# ISO 14064-2 Verification Report

**“Afforestation, Reforestation and  
Revegetation (ARR) activities”  
undertaken by ACEN  
CORPORATION**

**Report No:** CCIPL1856/ISO/VER/ARR/20230414

**Report Date:** 19<sup>th</sup> April 2024

2003 Land Cover

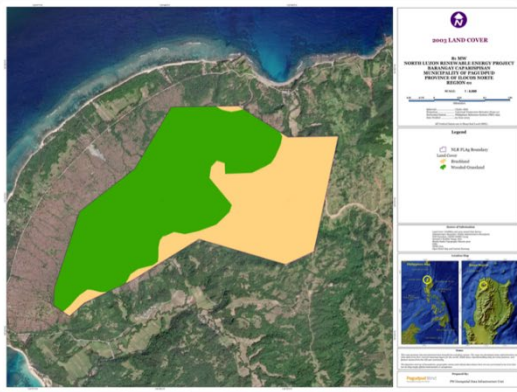
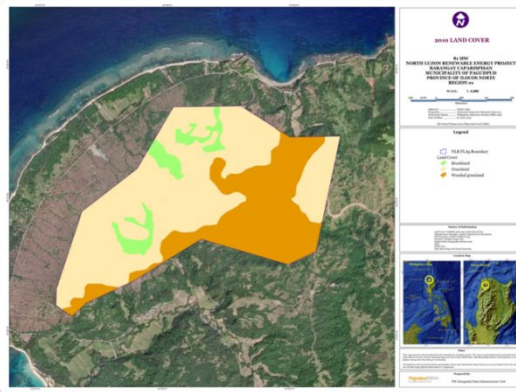
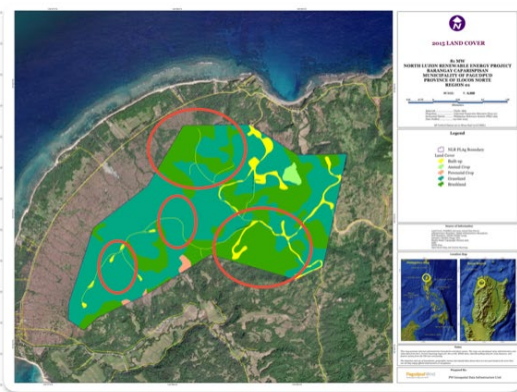
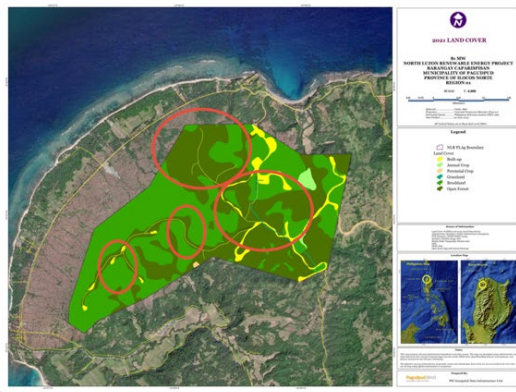
| <p>PP is requested to revise the project carbon document determining the GHG baseline considering the following as per the section 6.4 of the ISO 14064 2:2019:</p> <ul style="list-style-type: none"> <li>• Identified GHG SSRs (Sinks, Sources and Reservoirs)</li> <li>• Data availability, reliability and limitations</li> <li>• Other relevant information concerning present or future conditions, such as legislative, technical, economic, socio-cultural, environmental, geographic, site-specific and temporal assumptions or projections.</li> </ul> |                         |

map, and the Brushland category in 2015 is designated as Open Forest Land in the 2021 map.

| <p style="text-align: center;"><b>2021 Land Cover</b></p>   | <p style="text-align: center;"><b>2021 Google earth imagery 03-2021</b></p>  |

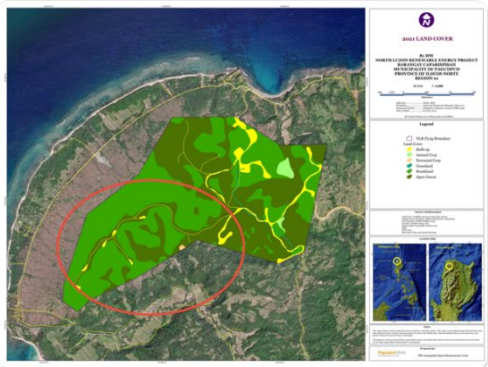
- 2. In Land cover map 2021 areas of open forest have infrastructure inside (Built up and paved or ballasted roads), (for better definition of forest should split).

| <b>2003 Land Cover</b>   | <b>2003 Lansat 7</b>   |

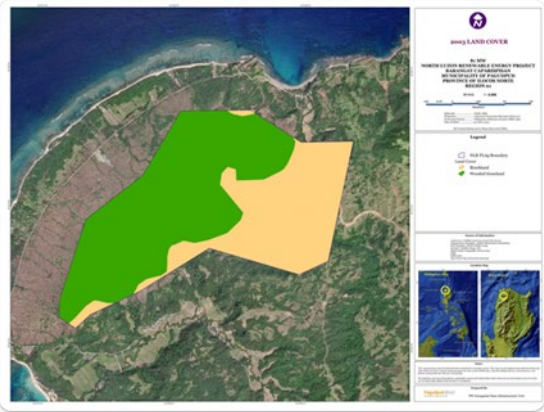
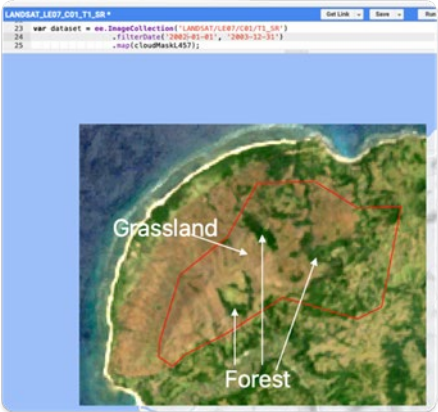
| <p>The files shared by PP exhibit inconsistencies that are incongruent with the requirements of ISO 14064-2 Standard; kindly refer the explanation of these inconsistencies below:</p> <ol style="list-style-type: none"> <li>1. LULC files provides don't match with the contrasted information available for the project, also taking in consideration the scale of LULC done by NAMRIA and the geographic scale of the project, in the figure below is clearly evidenced that LULC 2003 doesn't match with the image for the same year, is evident that forest areas not corresponding with contrasted imagen for the same reference year.</li> <li>2. Additionally, it is recommended to adjust the LULC scale to the project to demonstrate the conditions prior of the beginning of the project; furthermore, Lansat images data sources and other available sources can be used to have a better fitted of the LULC adjustment for 2003.</li> </ol>                     |  |
